The following information is meant to address the concerns of both the appellants and the commissioners that were raised regarding the approval of the 10510 S.W 155th Ave. 3-Lot partition.

Tract "A" & 3-Lot Partition-10510 SW 155th Ave

3-Lot Partition Plan (Rev. 11/22/16)

Tract "A" & 3-Lot Partition-10510 SW 155th Ave  
T: 1S, R: 1W, Sec: 32BD, TL: 100 (EMS 15-0057)  
Wetland Boundary Delineation Map (Rev. 11/17/16)

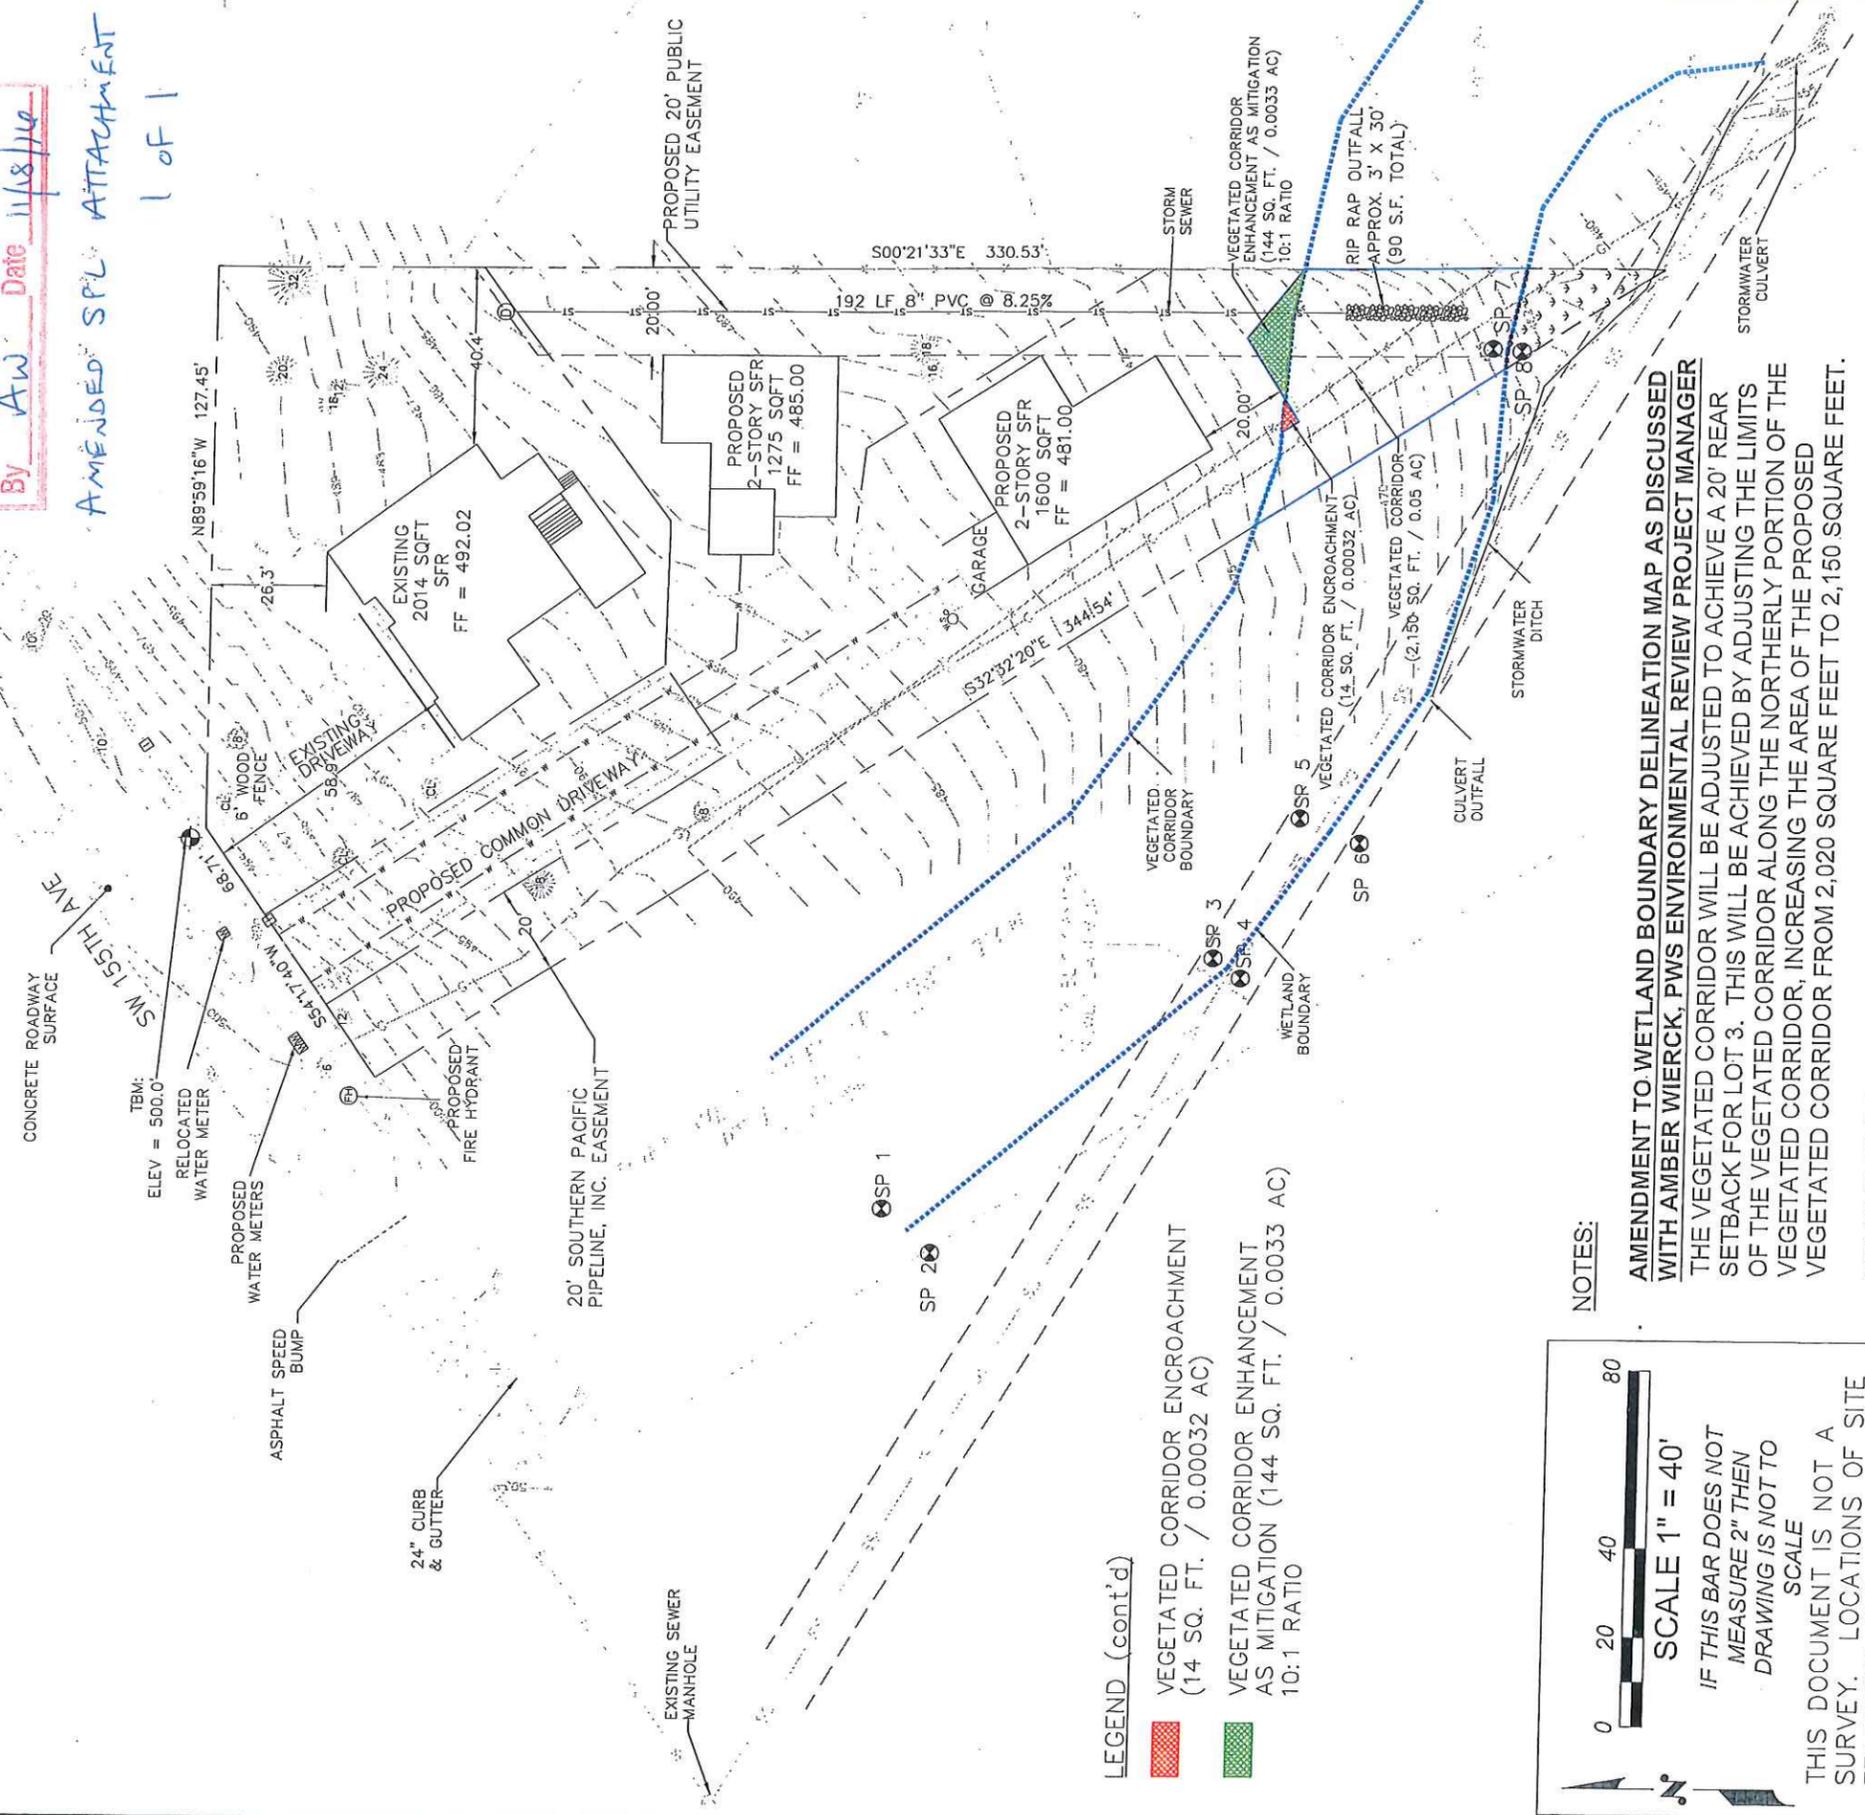
7) In their letter dated Nov. 9, 2016, the appellant asked for an updated Service Provider Letter from Clean Water Services. Please see the new CWS letter and map, which states their approval of the partition.

We have withdrawn our application for any Flexible Setbacks. By enhancing the Vegetated Corridor, we have met the 20' backyard requirements.

**AMENDMENT TO WETLAND BOUNDARY DELINEATION MAP AS DISCUSSED WITH AMBER WIERCK, PWS ENVIRONMENTAL REVIEW PROJECT MANAGER. THE VEGETATED CORRIDOR WILL BE ADJUSTED TO ACHIEVE A 20' REAR SETBACK FOR LOT 3. THIS WILL BE ACHIEVED BY ADJUSTING THE LIMITS OF THE VEGETATED CORRIDOR ALONG THE NORTHERLY PORTION OF THE VEGETATED CORRIDOR, INCREASING THE AREA OF THE PROPOSED VEGETATED CORRIDOR FROM 2,020 SQUARE FEET TO 2,150 SQUARE FEET. REMOVE INVASIVE NON-NATIVE SPECIES WITHIN THE CORRIDOR BY HAND AND REVEGETATE CLEARED AREA VIA LOW IMPACT METHODS.**

DRIVEWAY PROFILE (Rev. 11/22/16)

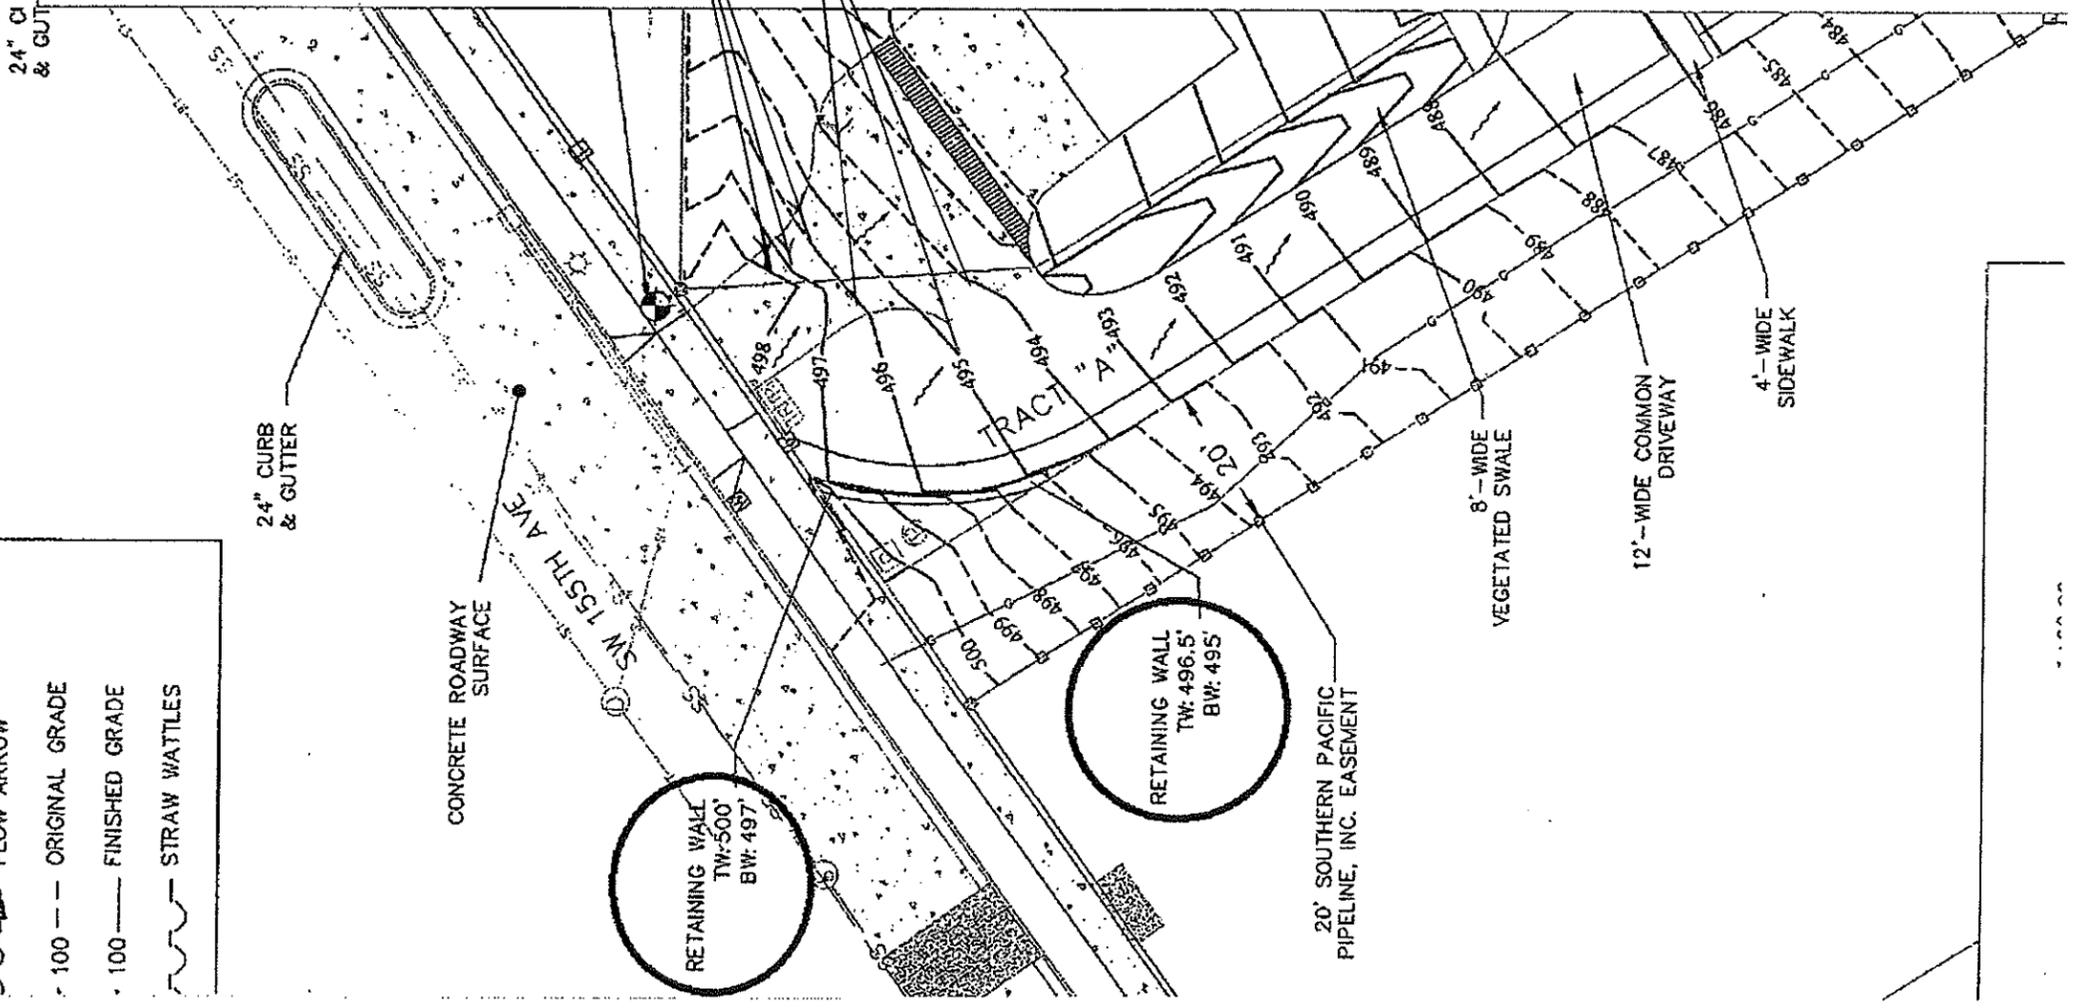
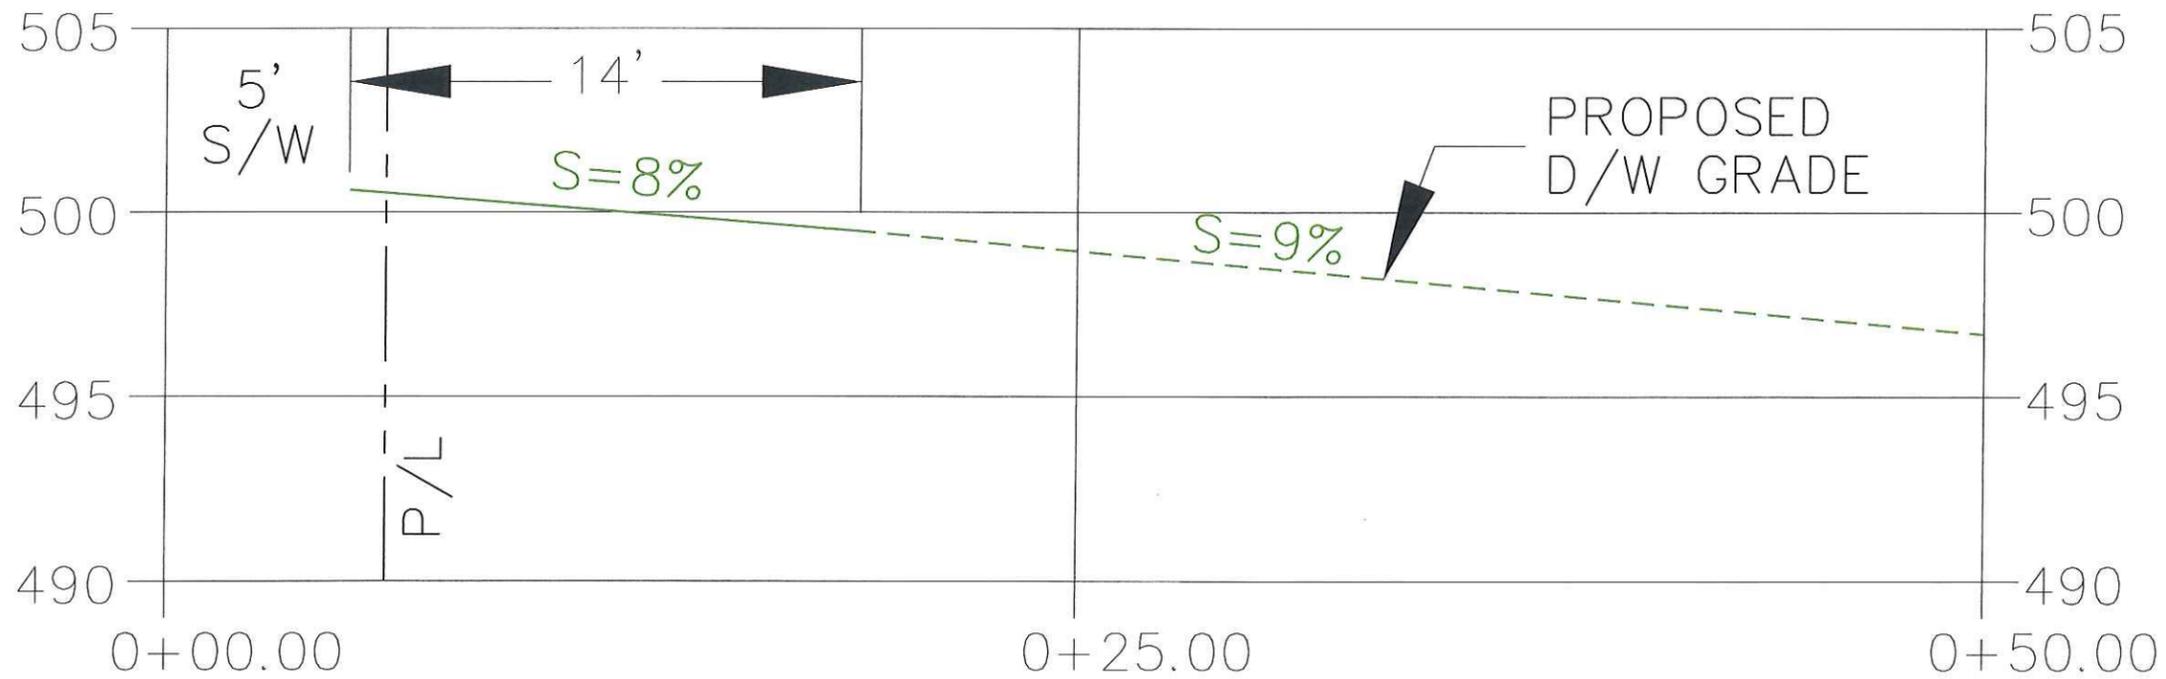
5) Outstanding traffic issues traffic safety issues: We agreed that traffic safety at this location is very important. As Commissioner Wilson noted there is a definite traffic safety vision problem with respect to the slope of the current driveway.

Mr. King's attorney stated that our proposal to rectify this problem "is simply not true and that the proposed driveway would further diminish visibility and exacerbate this traffic safety problem."

This is a very simple math calculation. In order to determine degree of slope, all you need to do is divide the rise in elevation by the run, that is, the length involved. (Please see Exhibit 3), to make the matter even more clear we have provided a profile of the existing driveway and the proposed. Also, her contention that raising the back of the driveway approach makes the slope worse is simply not true. This is very easy to demonstrate, this is demonstrated at the walking path just a few feet to the west of the property.

Because the new driveway now allows a much shallower approach to SW 155th Ave., for much better visibility, and because the driveway will no longer have its sight impeded by brush, it is easy to see that a much greater safety level is achieved.

The formula for determining slope is rise ÷ run.  
 All of these contours are 1' increments, so the closer they are to each other - the steeper the slope.

Very close  
 22 1/2% slope  
 8% slope
